# Technical *data*

CT 939 K2/K3 & CT1120K1 timing belt kit, used for example in:  
VW / Audi 2.5 TDI 5 cyl.

Fig. 1  
Washer

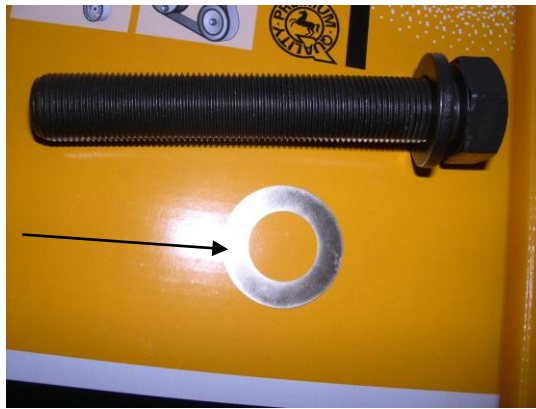
In accordance with the updated equipment status, the timing belt kit contains a thin washer (diamond-coated) that was not previously installed in the vehicle.

According to the VW/Audi catalog, this special washer (4) is to be installed between the crankshaft drive wheel (3) and the torsional vibration damper (5). This is intended to improve the co-efficient of friction.
